REPORT ON PROPOSALS

THE WATER EFFICIENCY AND SANITATION STANDARD
TECHNICAL COMMITTEE REPORT ON PROPOSALS FOR
PUBLIC REVIEW AND COMMENT

Enclosed is your 2022 Report on Proposals (ROP).

FIGURE E 104.1
ONSITE WASTEWATER TREATMENT STAGES FOR DPR

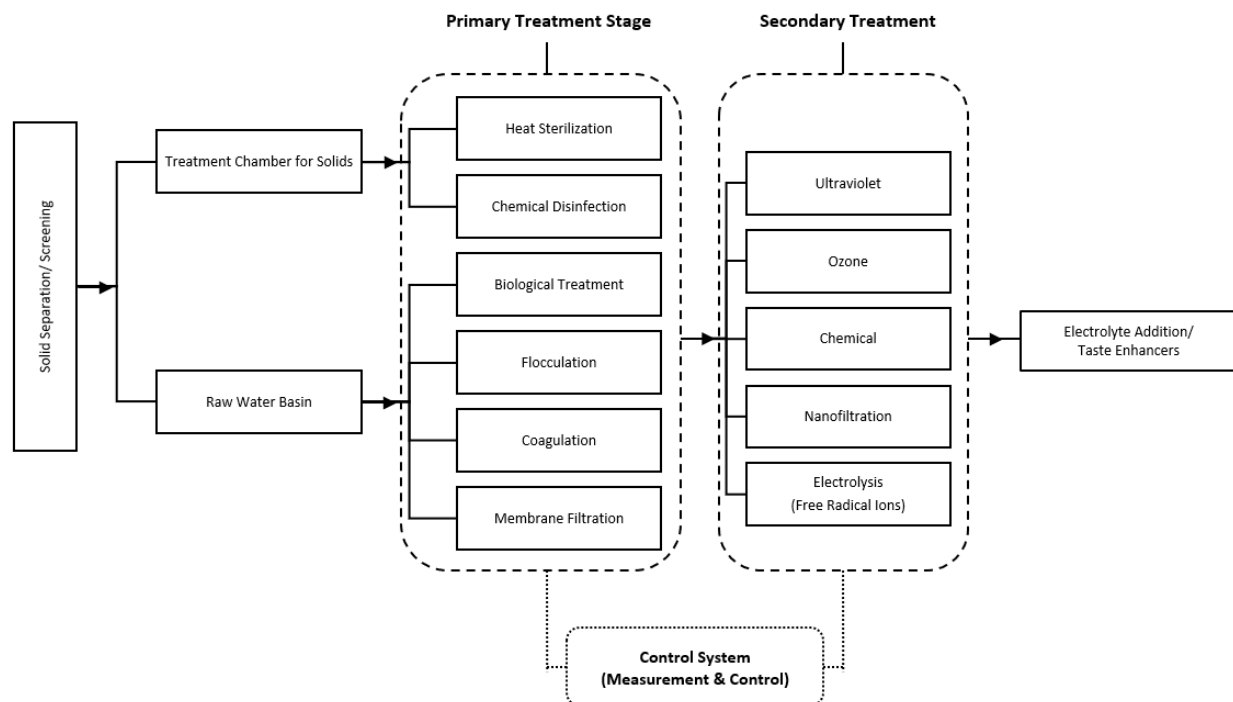
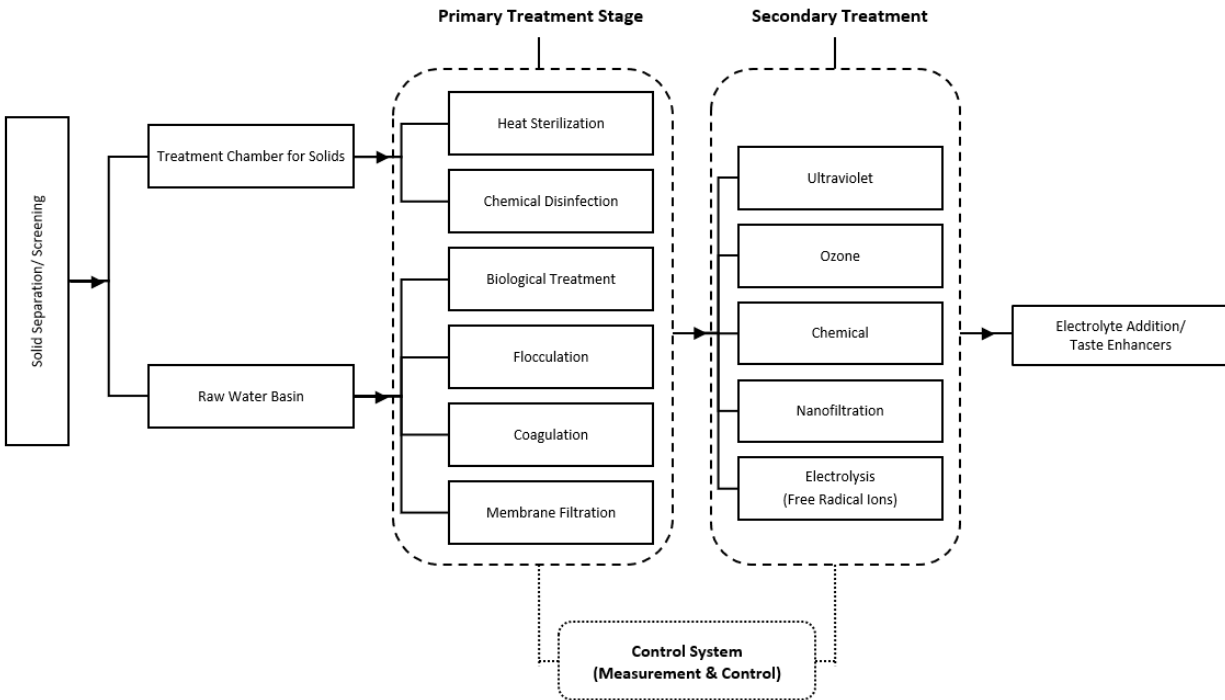
(See Figure E 104.1 for a flow diagram of treatment stages utilized in DPR systems.)

Note: To eliminate a single point of failure in the sterilization stage, an additional method of filtration is recommended between Stage 3 and Stage 4. The recommended level of filtration is 0.05 micron (0.05 μm).

FIGURE F 301.1(1)
GRAY WATER DRAINAGE SYSTEM- DIVERTER VALVE IN CRAWL SPACE

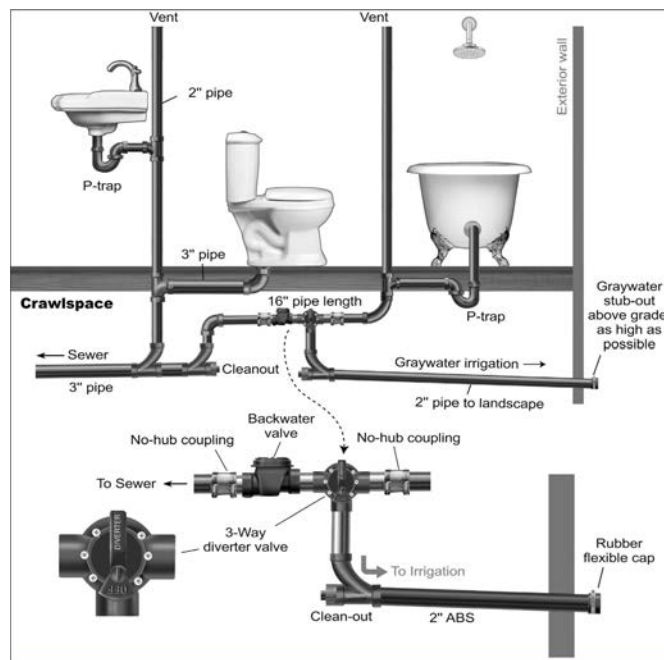
Figure F 301.1(1) illustrates graywater being collected from a first-floor shower/bath, with the diverter valve located in the crawlspace or basement.

FIGURE F 301.1(2)_
GRAY WATER DRAINAGE SYSTEM – SINGLE FIXTURE ON SECOND FLOOR NEAR EXTERIOR WALL

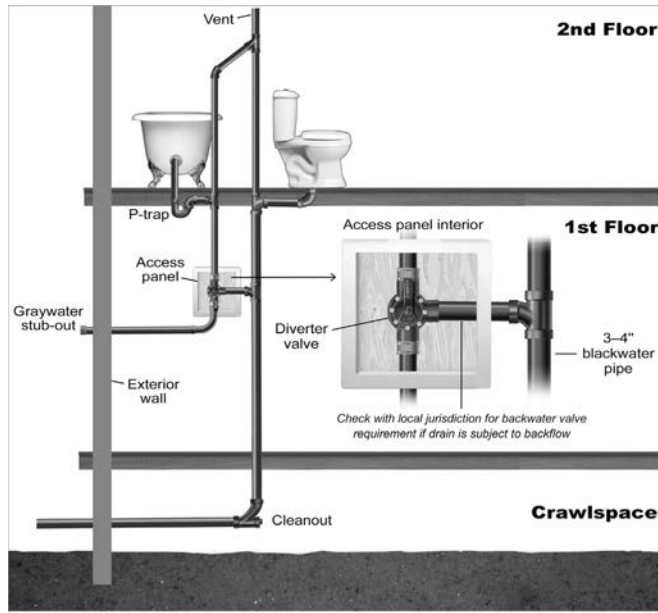
Figure F 301.1(2) shows graywater being collected from a second-story shower/bath, with the diverter valve located below the bathroom inside the wall of the first floor.

FIGURE F 301.1(3)_
GRAY WATER DRAINAGE SYSTEM – SINGLE FIXTURE ON SECOND FLOOR WITH STUB-OUT ABOVE GRADE, FROM CRAWL SPACE UNDER THE FIRST FLOOR

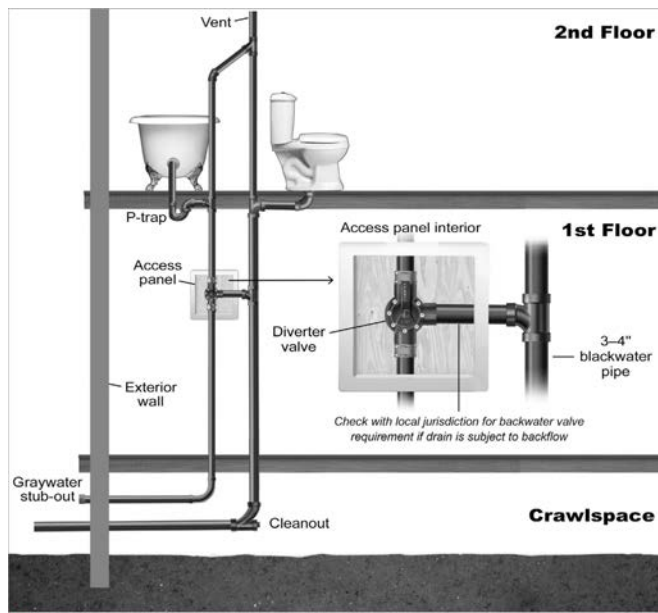
Figure F 301.1(3) shows the same plumbing set-up as installed in Figure F 301.1(2), except the shower/bath drain pipe runs through the first floor and into the crawlspace. The graywater stub-out is located outside of the exterior crawl space foundation wall or crawl space vent, above grade. This configuration may be applicable when fixtures are located in the interior of the building and a stub-out can't be piped easily through an exterior wall above floor level.

FIGURE F 301.1(4)
GRAY WATER DRAINAGE SYSTEM – MULTIPLE FIXTURES ON CONCRETE SLAB FOUNDATION

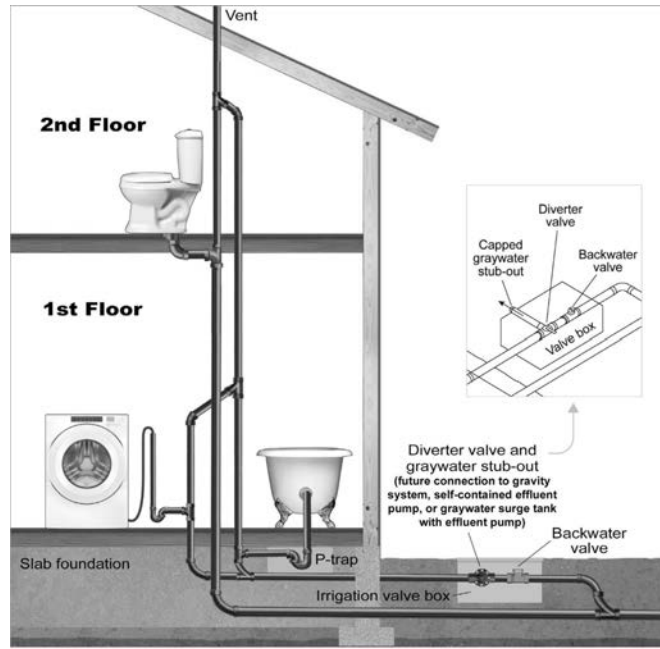
Figure F 301.1(4) shows graywater diversion from the shower/bath and clothes washing machine in a house with a slab-on-grade foundation, where the diverter valve is located outside the building envelope in a subsurface enclosure (i.e., an irrigation valve box). The subsurface enclosure containing the diverter valve needs to be permanently accessible (i.e., no structures or hardscape covering it). The diverter valve should be positioned as high as possible in the enclosure to ensure graywater can drain at a 1/4 inch per 12 inch slope into a future gravity irrigation system or pump basin.

FIGURE F 301.1(5)
GRAY WATER DRAINAGE SYSTEM – GRAYWATER PIPING EXTENDS OUTSIDE SLAB FOR ACCESS, THEN RETURNS INTO SLAB TO JOIN OTHER DRAINAGE PIPING

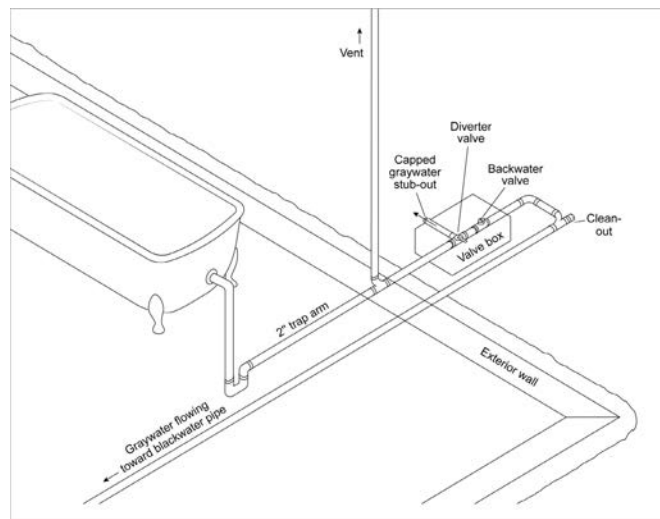
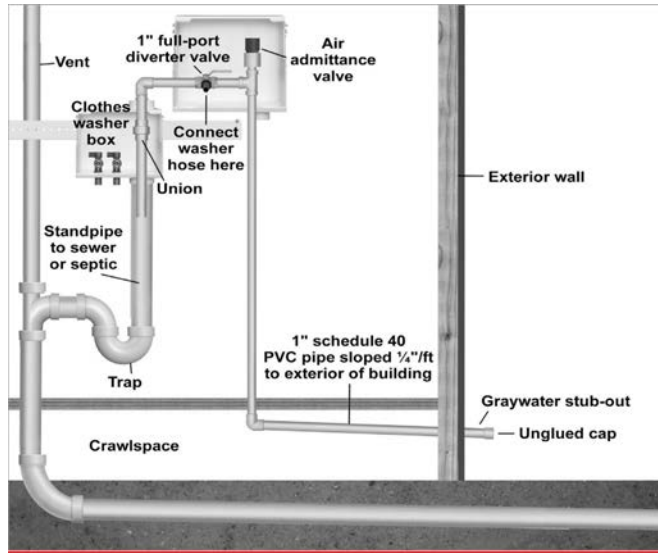
Figure F 301.1(5) demonstrates how to make graywater from a tub/shower (or other fixture) accessible when the bathroom is on a slab and the main drain is in another area of the building. The tub/shower drain has been directed through the slab and perimeter foundation to a subsurface enclosure (i.e., an irrigation valve box). A diverter valve and backwater valve are located in the box, providing a graywater stub out. The tub/shower drain then loops back through the foundation and into the slab to proceed to where it connects with the building's other drainage piping. 1/4 inch per 12 inches of slope must be carefully maintained on this loop piping

**FIGURE F 301.1(6).
GRAY WATER DRAINAGE SYSTEM – CLOTHES WASHER GRAYWATER SYSTEM WHERE GRAYWATER
IRRIGATION PIPE IS RUN THROUGH CRAWLSPACE**

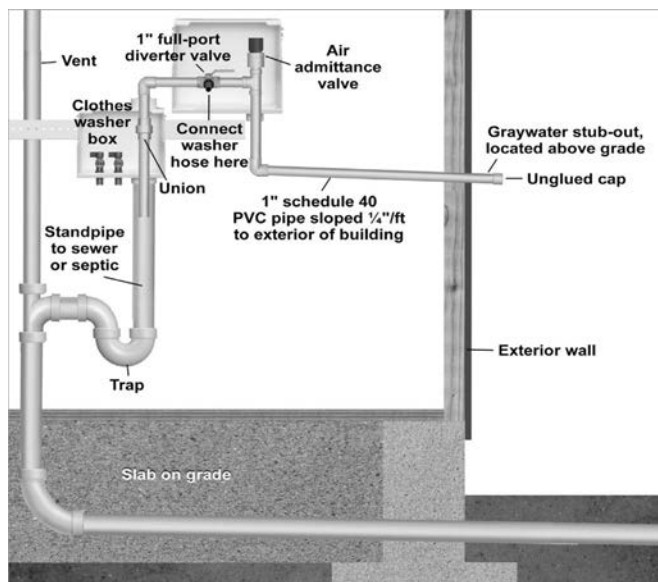
Figure F 301.1(6) illustrates laundry-to-landscape piping in a building with a crawl space.

**FIGURE F 301.1(8)
OVERVIEW OF A GRAVITY-FLOW, BRANCHED DRAIN SYSTEM**

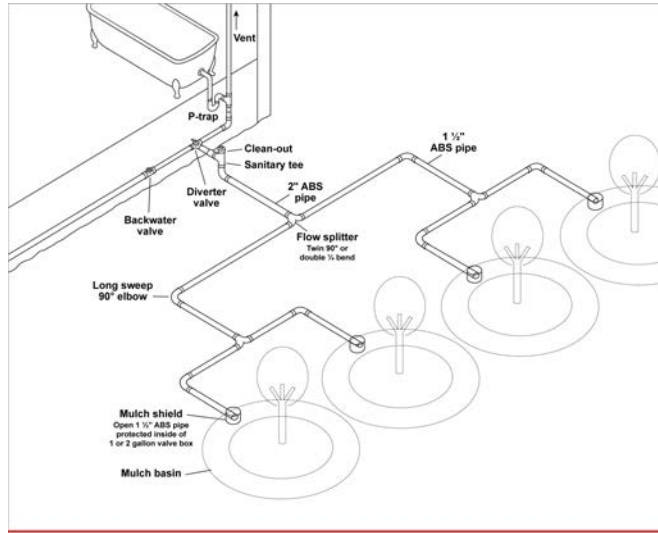
Figure F 301.1(8) demonstrates a conceptual image of how a gravity-flow, branched drain graywater system transports graywater to multiple landscape plants without a storage tank or pump.

**FIGURE F 301.1(9)
OVERVIEW OF PUMPED GRAYWATER TO IRRIGATION SYSTEM**

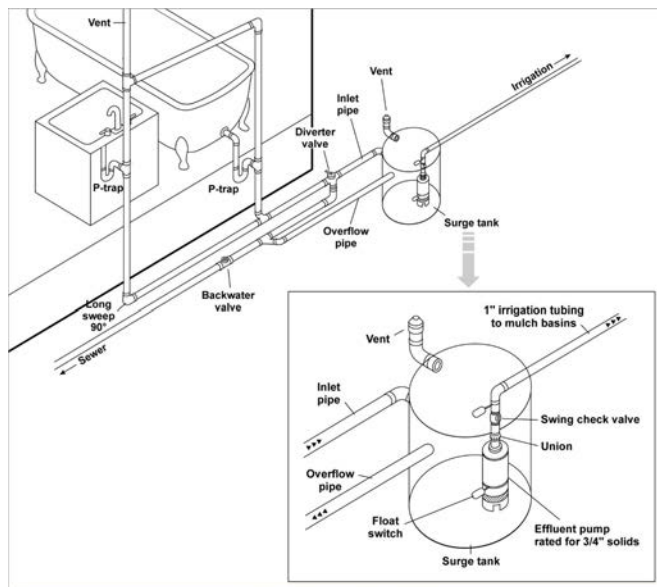
Figure F 301.1(9) shows graywater from a lavatory and tub/shower being made available for irrigation. All of figures were gathered from the Guidance on Ordinance Compliance in Illustrations which may be accessed via the following link:
https://localenergycodes.com/download/787/file_path/fieldList/CCGA%20Illustrated%20Compliance%20Guidance.pdf
